Questions regarding RfG
(EU2016/631) to be presented to
the ACER Grid Connection
European Stakeholder
Committee

Response Time to LFSM-O

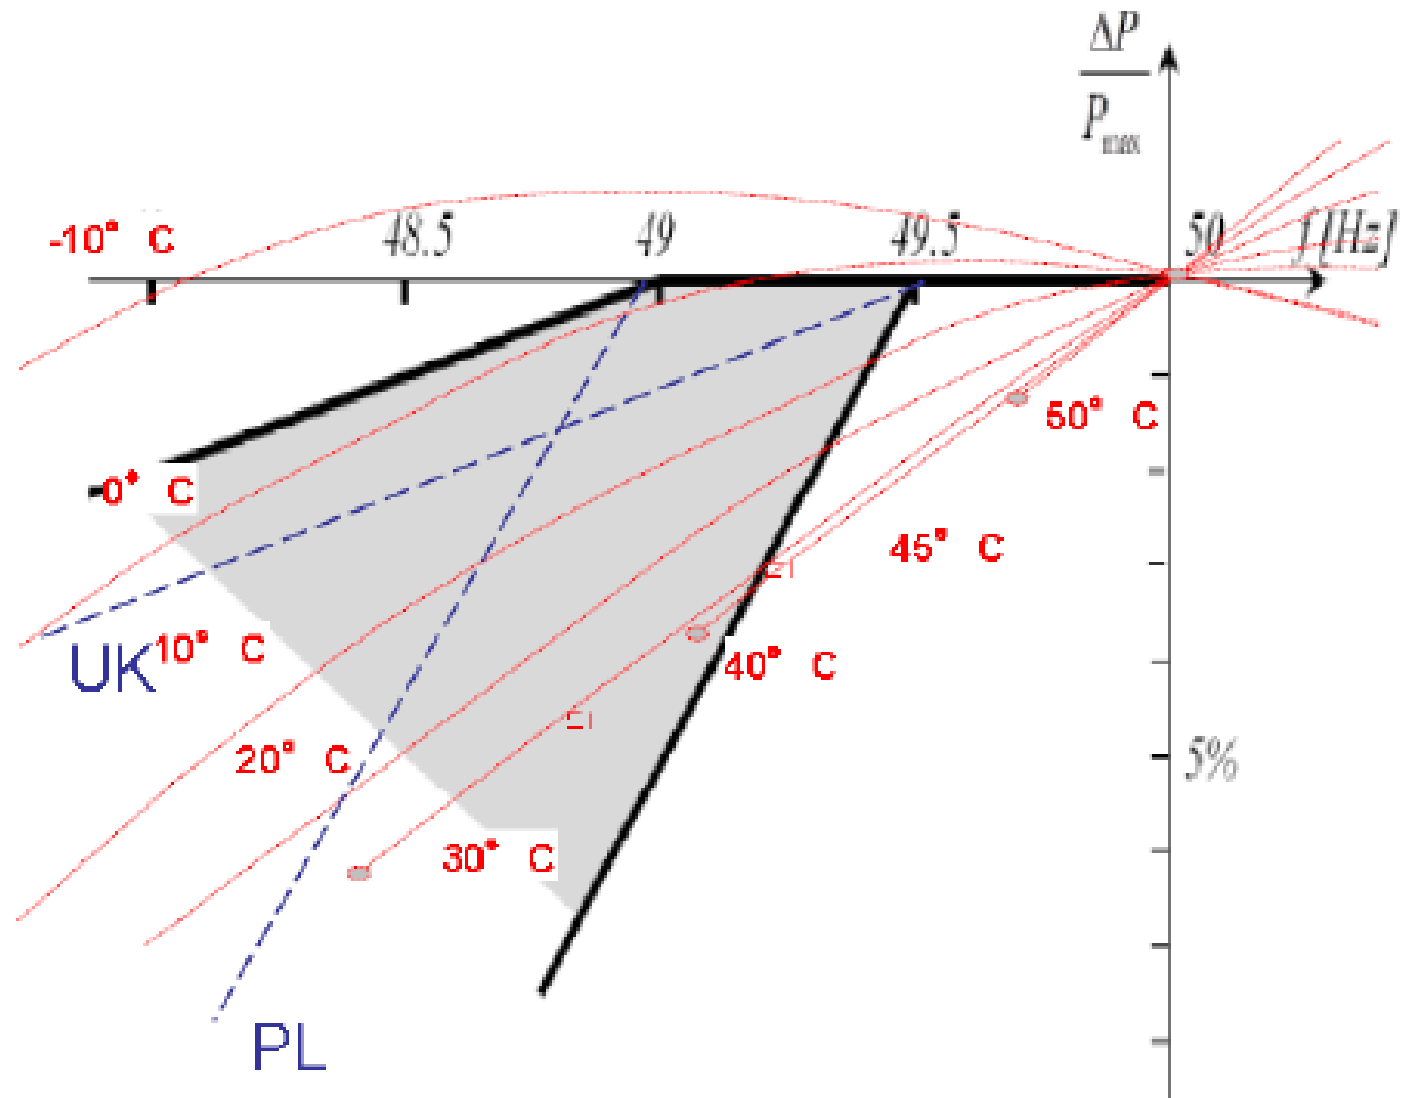
Article 13 (2) does not state a required response time, but only state an initial delay, interpreted as a dead time.

CENELEC conducted a survey among manufacturer in 2015.

Typical response time up to 1s is acceptable for PV technology. For other technology a longer response time is expected up to 15-30 sec depending on technology.

Response time within TS 50549 is 2s with allowance of of staged disconnection (not permitted for generating of type B, C&D)

CENELEC: Based on CENELEC survey to include all technologies a response time between 15s and 30s shall be considered. To be confirmed if this is feasible according to RfG.
